SUBJECT: Responds to questions raised at 850604 meeting re
 criticality safety analysis. Calculations & graphs prepared
 by Pickard, Lowe & Garrick, Inc encl.

Subject: Response to NRC Staff Questions
R. E. Ginna Nuclear Power Plant
Docket No. 50-244

At our meeting of June 4, 1985, the NRC Staff raised several questions concerning the criticality safety analysis. Attached, in response, are some additional calculations performed by Pickard, Lowe and Garrick.

FIGURE 2

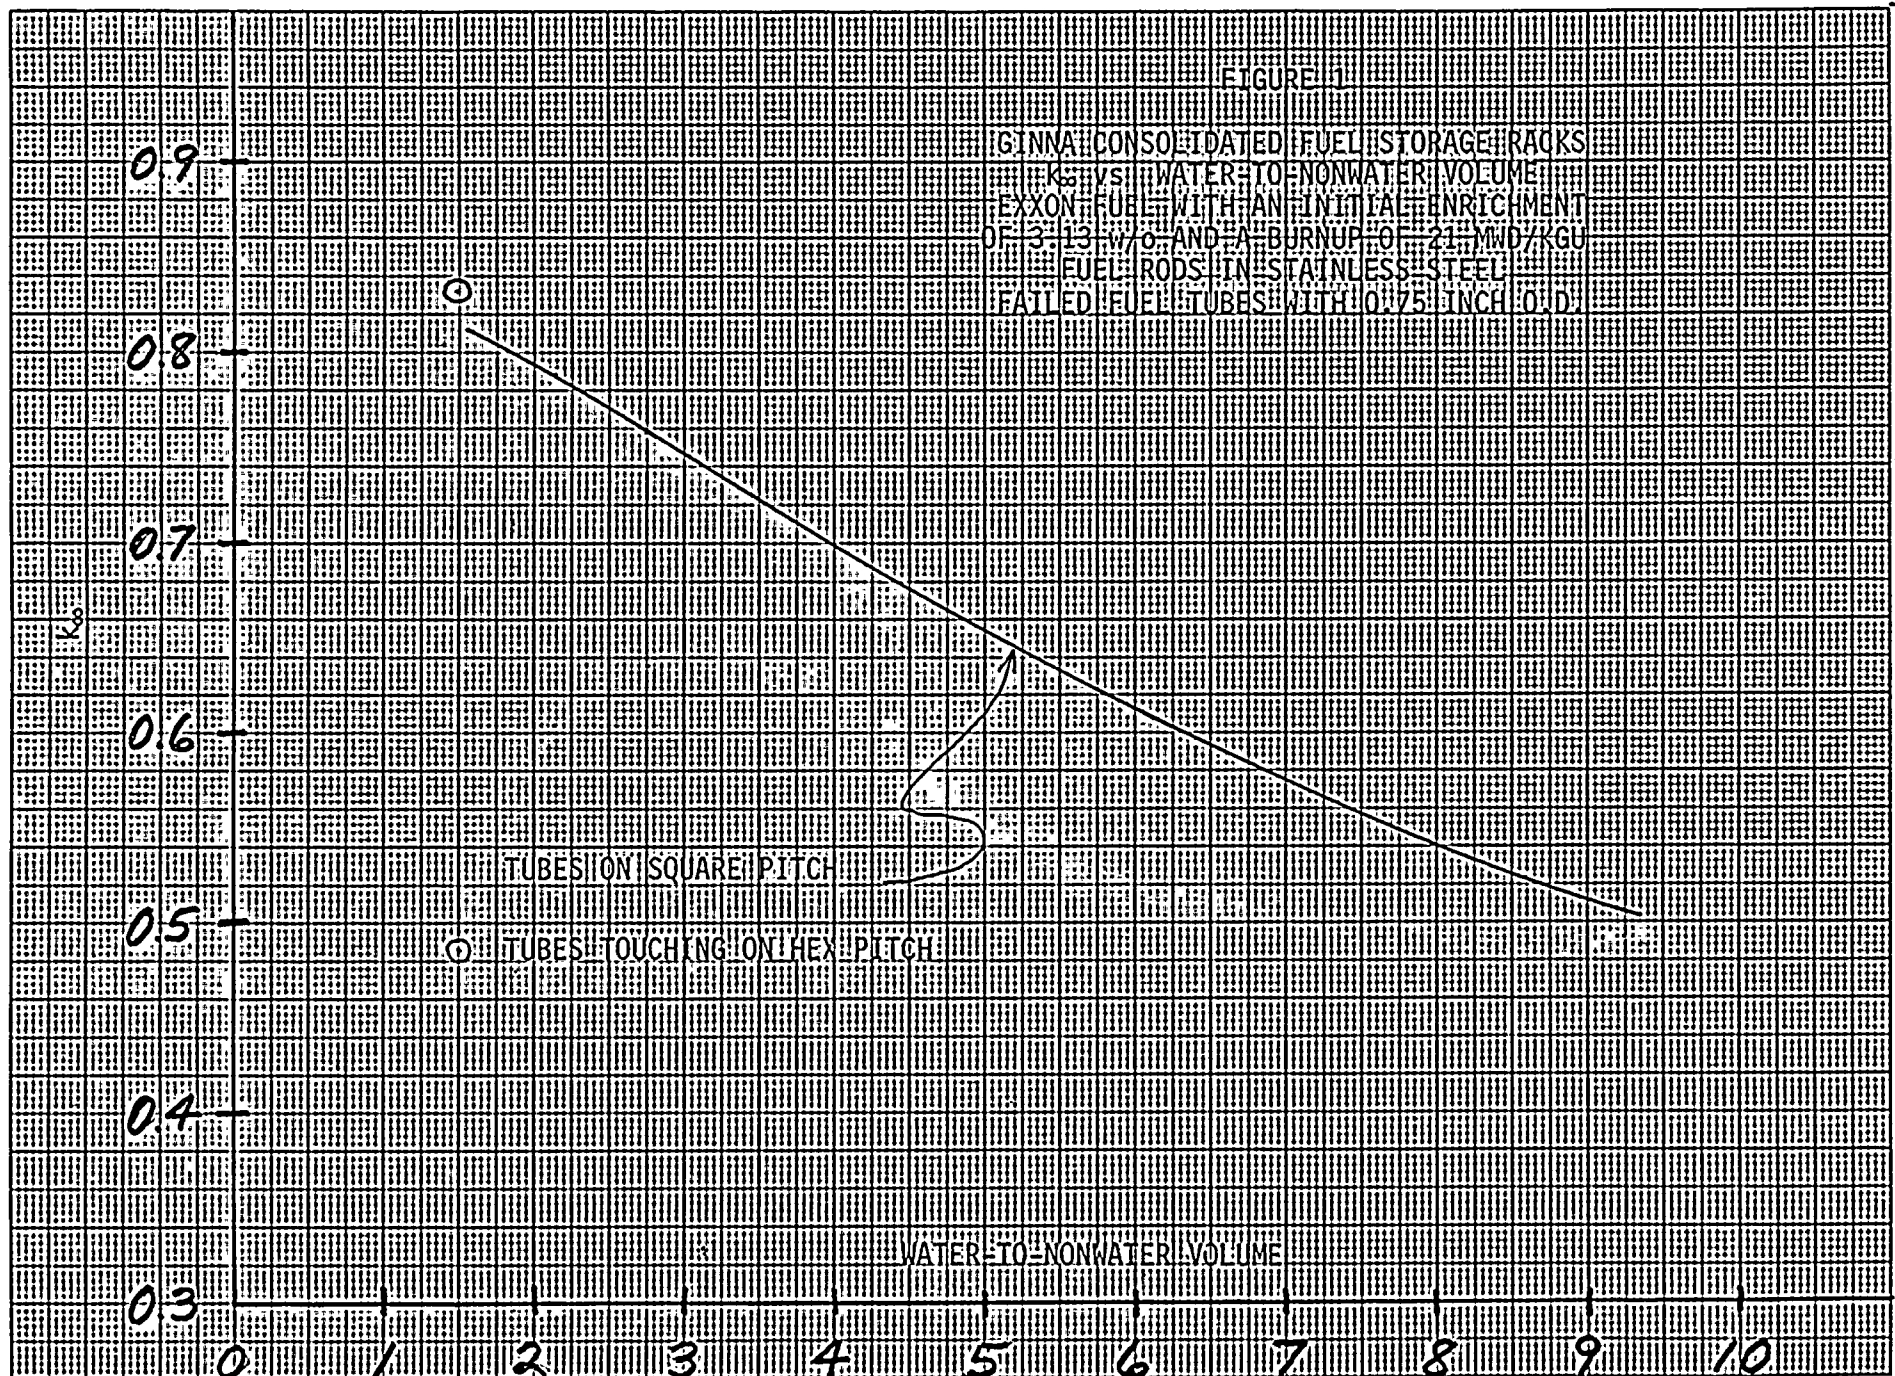
Question: Please discuss the effects on criticality of the storage of fewer than 179 rods per half canister such as in a failed fuel configuration.

A similar set of calculations were performed using the same fuel rods but without the presence of the stainless steel tubes. In this case the maximum number of fuel rods per half canister is 179. The results are shown in Figure 2 for both the k_{∞} of an infinite lattice and the k_{∞} of the storage rack containing the canisters. In this case, the maximum lattice k_{∞} is about 1.16, but the maximum rack k_{∞} is only about 0.87.

Figure 3 shows a comparison of k_{∞} vs. burnup behavior for an Exxon fuel assembly at 3.13 w/o and a 2.78 w/o fuel assembly stored at West Valley. The k_{∞} of the two types of fuel assemblies is the same for a burnup of 21 MWD/KGU; so the data shown in Figures 1 and 2 should also be applicable to West Valley fuel assemblies with a burnup of 21 MWD/KGU. However, the minimum burnup of the fuel assemblies stored at West Valley is about 15.5 MWD/KGU for an initial enrichment of 2.795 w/o. The k_{∞} of the 2.78 w/o fuel assemblies at a burnup of 15.0 MWD/KGU was selected as being representative of the minimum burnup - maximum k_{∞} fuel stored at West Valley, and based on the data shown in Figure 3, the difference in k_{∞} for this fuel at burnups of 21 and 15 MWD/KGU is $.0535 \Delta k_{\infty}$. This reactivity difference has been applied to the data generated for the Exxon fuel and the results are shown in Figures 4 and 5. These figures show that for the minimum burnup maximum k_{∞} fuel stored at West Valley, the maximum infinite lattice k_{∞} for the fuel rods in stainless steel tubes is about 0.88, and for the fuel rods stored in canisters in the storage rack, the maximum k_{∞} is about 0.93. However, a situation in which between 75 and 100 fuel rods per half canister are uniformly spaced in more than one storage rack position would have to be considered a low probability accident situation. In that case, credit should be allowed for the presence of 2000 ppm boron which would further reduce the k_{∞} of the rack by more than $.20 \Delta k_{\infty}$.
